Request for Additional Information No. 30, Revision 0

U. S. EPR Standard Design Certification

AREVA NP Inc.

**SRP Section: 15.06.05 – Loss of Coolant Accidents Resulting From Spectrum of
Postulated Piping Breaks Within the Reactor Coolant Pressure Boundary**

Figure 15.06.05-16-18—In-core Temperature

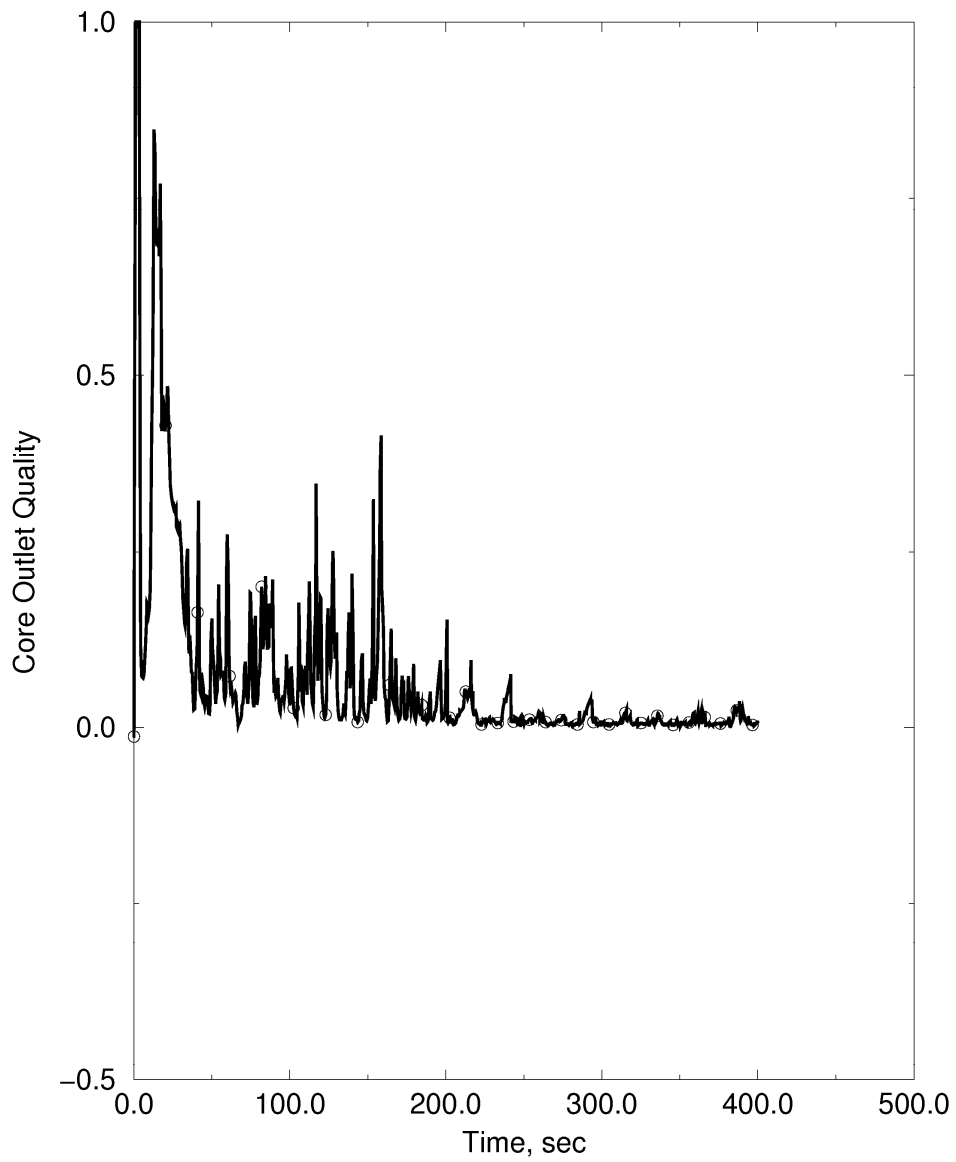
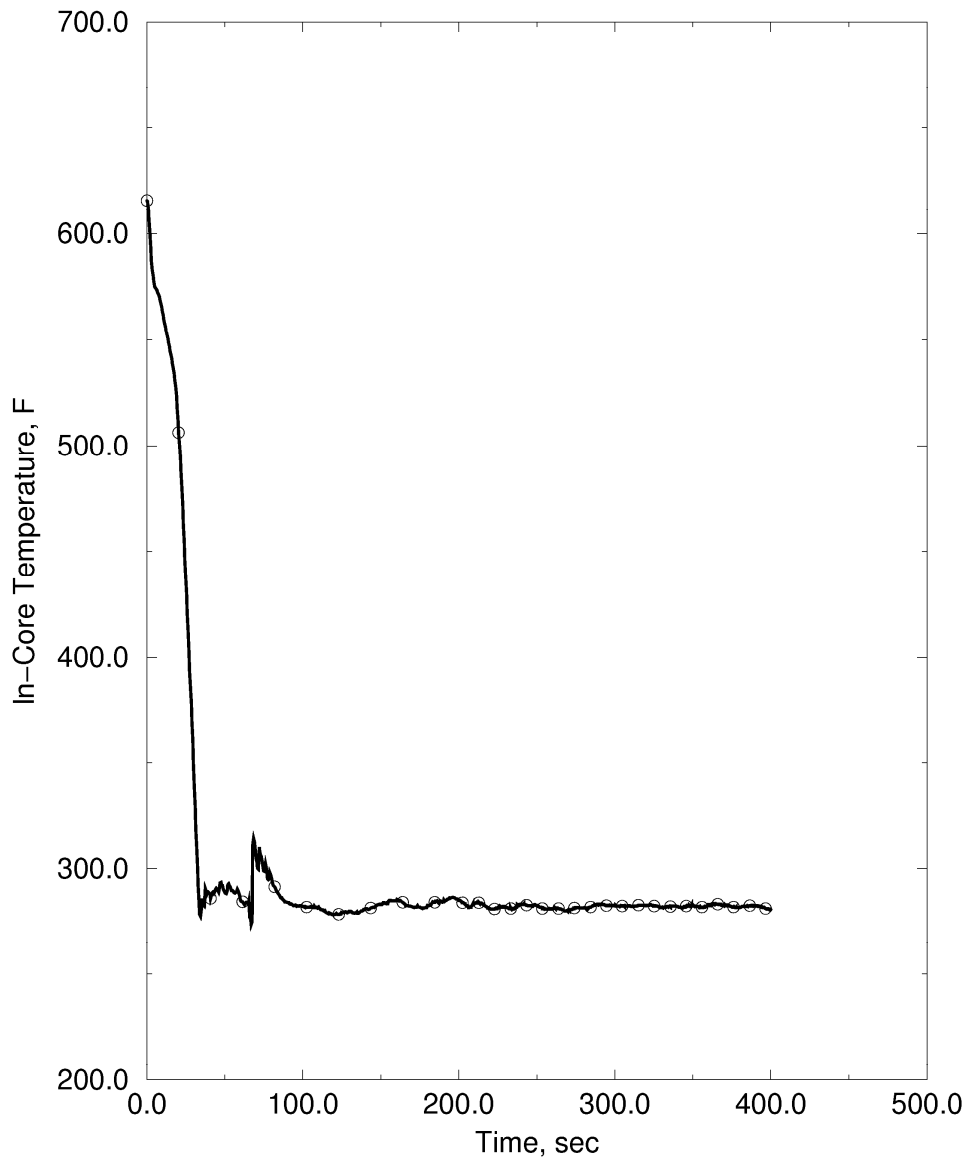
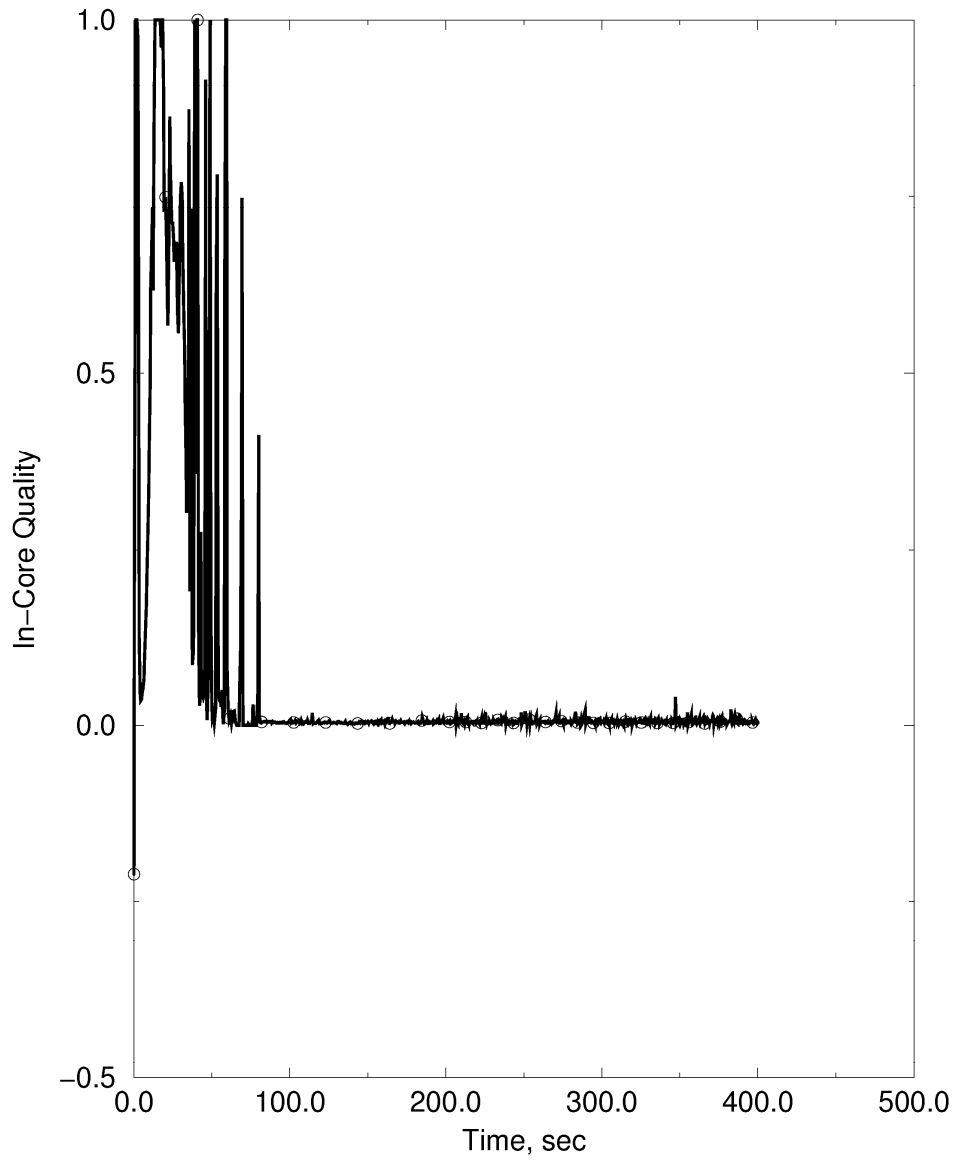
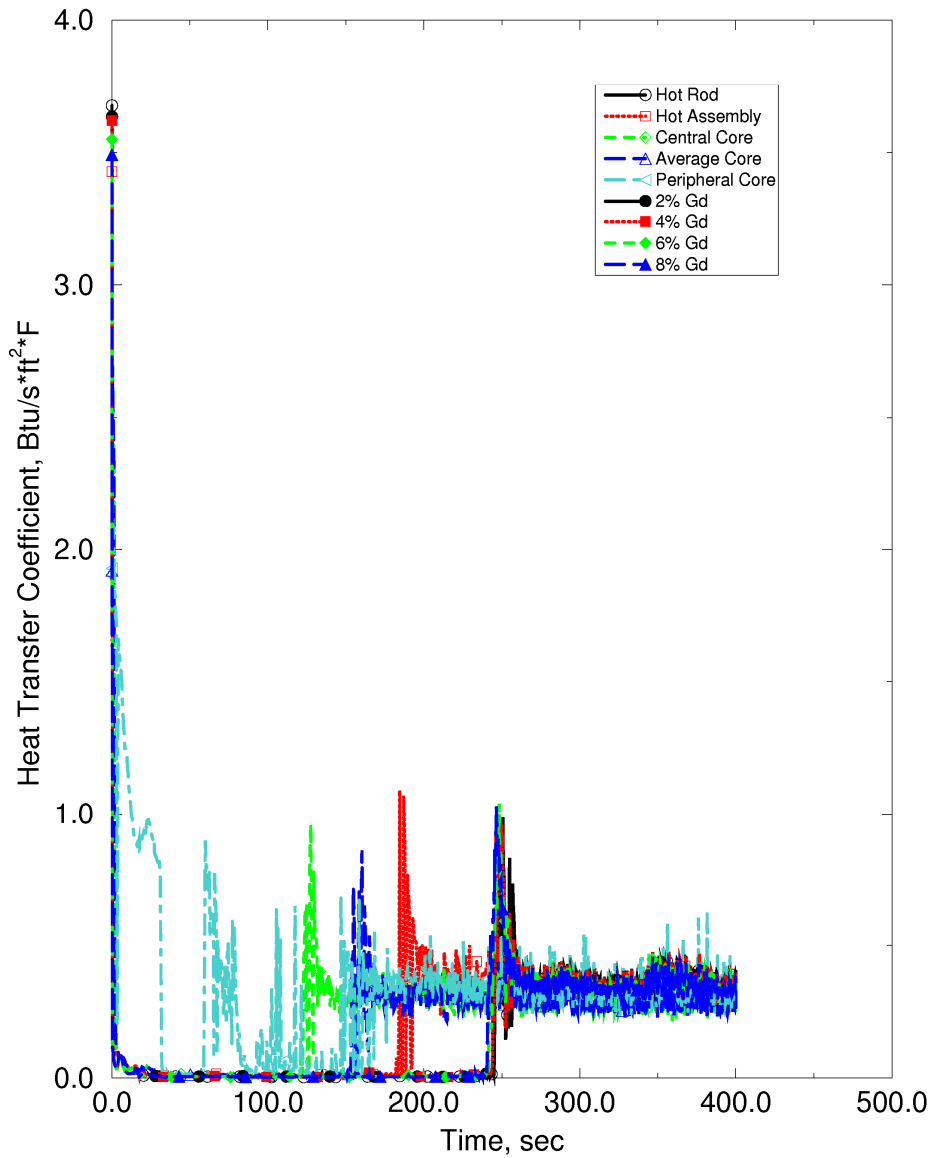
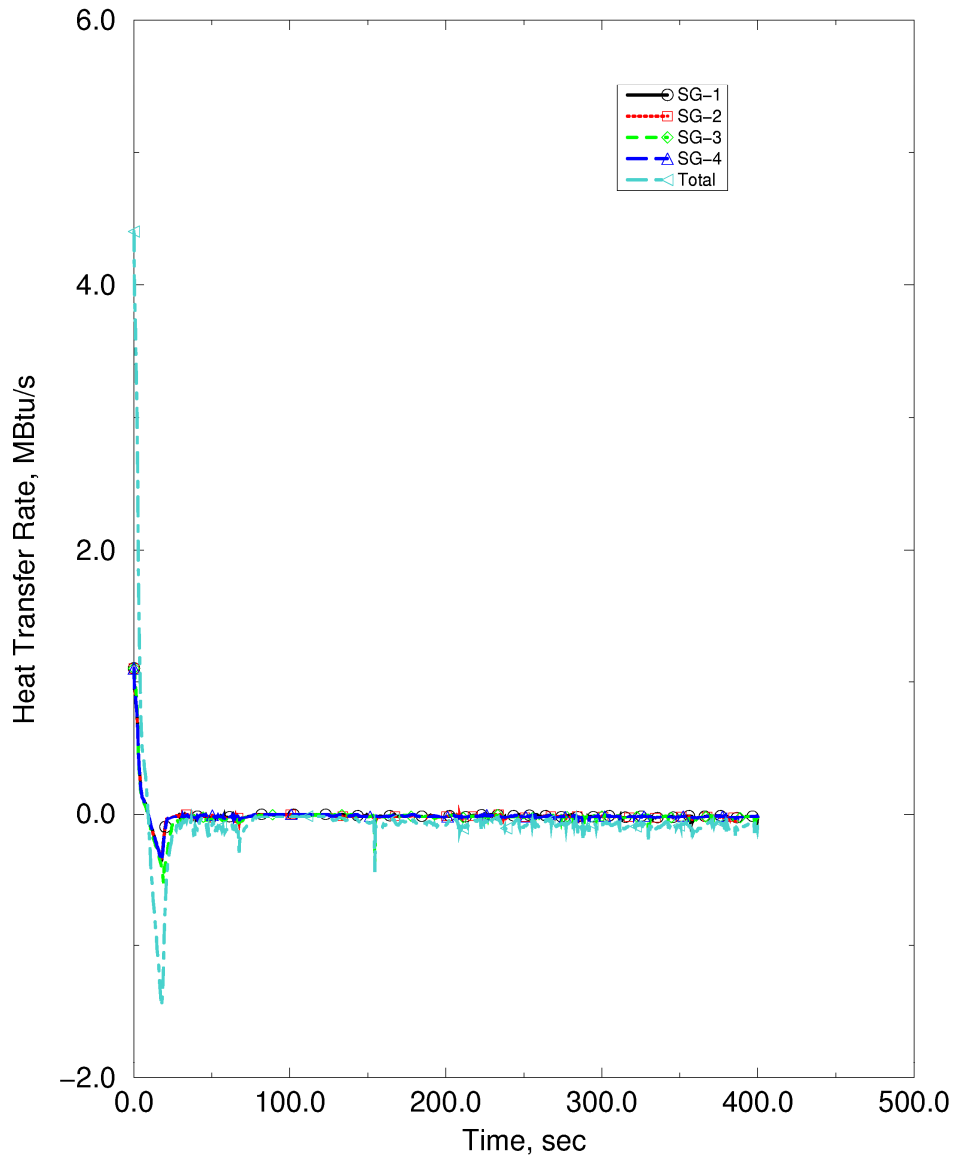
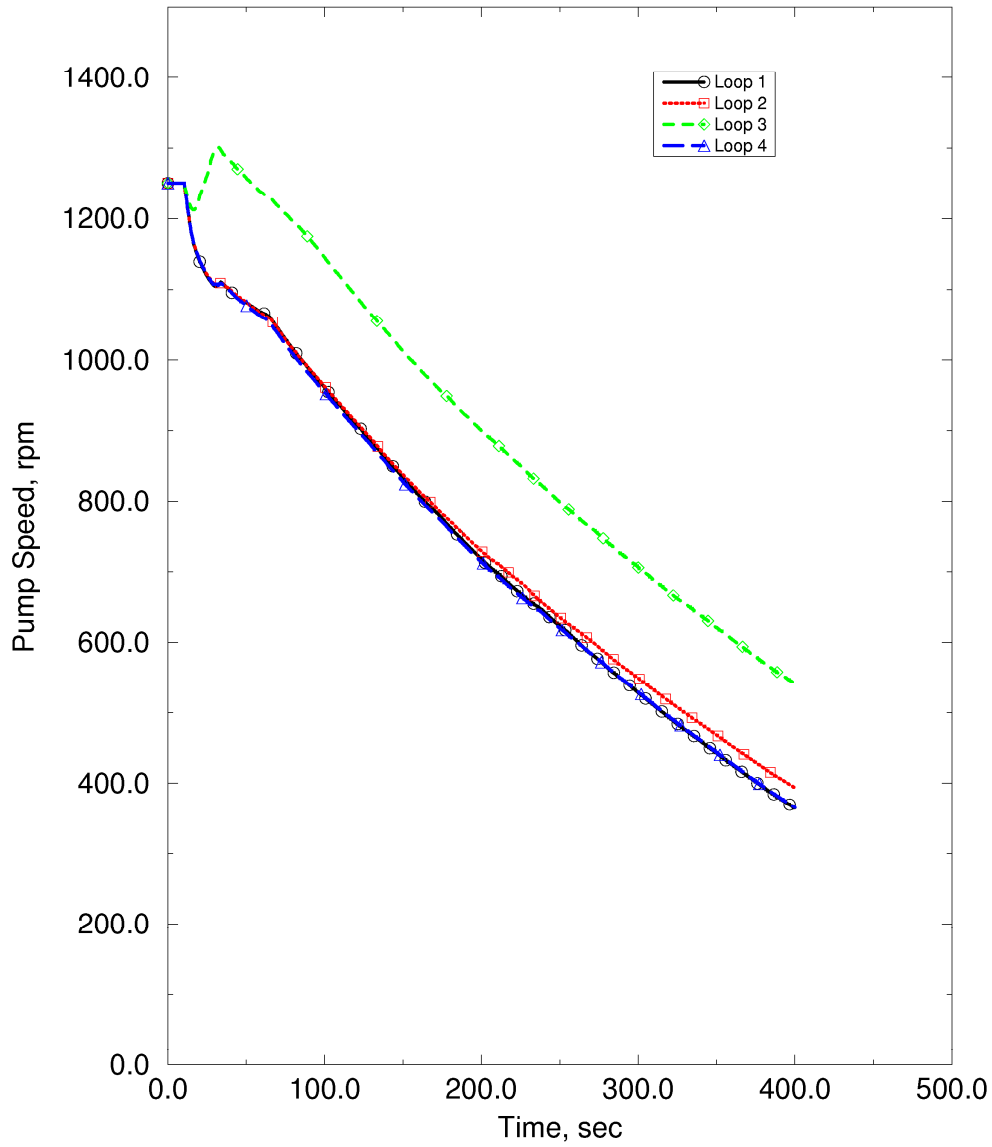
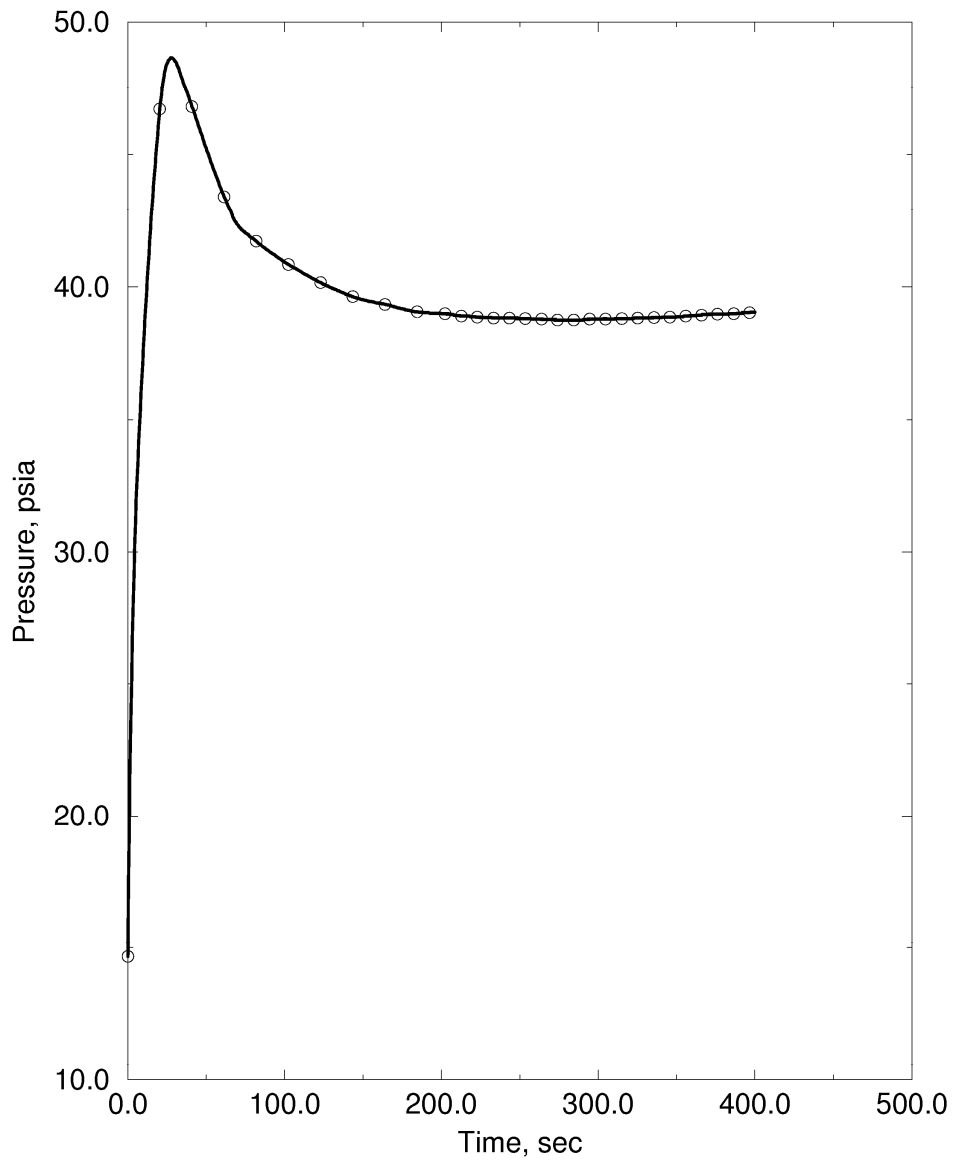
Plotted information has only been provided for the equilibrium cycle case. Please provide a set of plots similar to FSAR Figures 15.6-27 through 15.6-50 for the limiting PCT initial cycle case.

The requested figures are provided.
